## 8.4. Planning Proposal PP5/20 - 52 Alfred Street South, Milsons Point

**AUTHOR:** Karen Buckingham, Executive Strategic Planner

To present to Council the assessment of a Planning Proposal which seeks to amend the North Sydney Local Environmental Plan 2013 (NSLEP 2013) as it relates to land at 52 Alfred Street South, Milsons Point following its review by the North Sydney Local Planning Panel which is included.

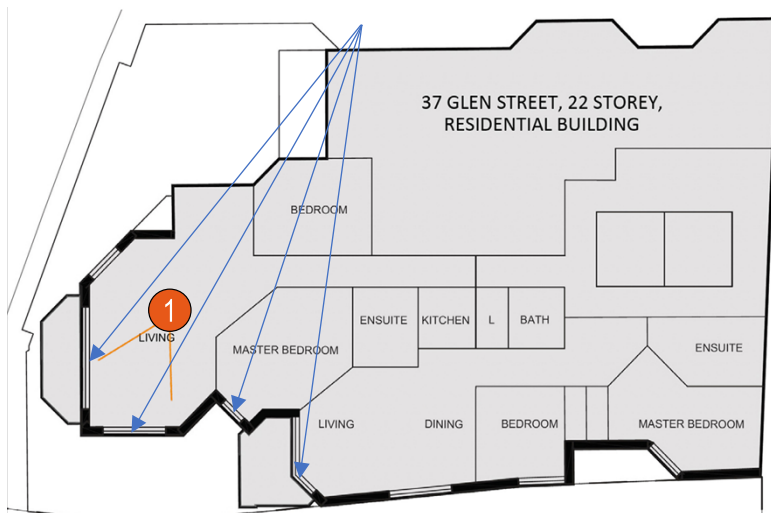
*The North Sydney DCP 2013 requires that there is to be no increase in overshadowing to Bradfield Park between the time of 12pm and 3pm. The revised Indicative Concept Scheme claims that a building can be accommodated within the proposed height(s) without resulting in additional overshadowing to the surrounding public domain.*

*With regard to the Milsons Point Character Statement, the proposal is generally compliant with podium controls other than the requirement for the tower fronting Alfred Street to have a 3m setback. Only 2m is proposed.*

*The amended concept plans tendered for the planning proposal still exhibit a number of issues with regard to the design principles set out in SEPP 65 and associated Apartment Design Guidelines which may not be able to be supported within the scope of a development application. These include (but are not limited to)*

- *Building Separation distances substantially under the minimum requirements.*
- *Inadequate separation should not unreasonably result in the loss of existing views from adjoining apartments.*

**Figure 14** - [Extract – VIA page 62, View 1]

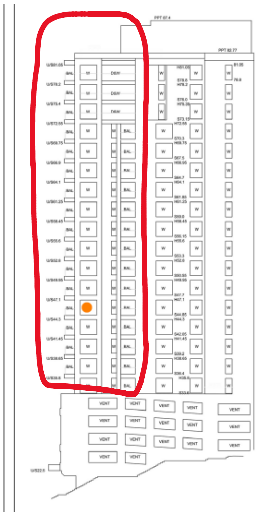
Key viewpoints from windows and balconies given the layout of apartments at 37 Glen Street

Main view windows impacted at 37 Glen Street

Plan view of camera - Level 12 (RL 44.85m)

Southern Elevational view of camera

*It may be difficult to protect the above view from a building that is compliant with the 40m height control and compliant building setbacks. I believe that these views could be maintained with additional side setbacks of the proposed tower at the north west corner of the Glenn Street tower. A view line needs to be established at the corner that is setback [at least] 3m from the street and 12m from the side boundary up to a height of 25m and a corner set back 3m from the street and 18m from the side boundary for heights over 25m.*
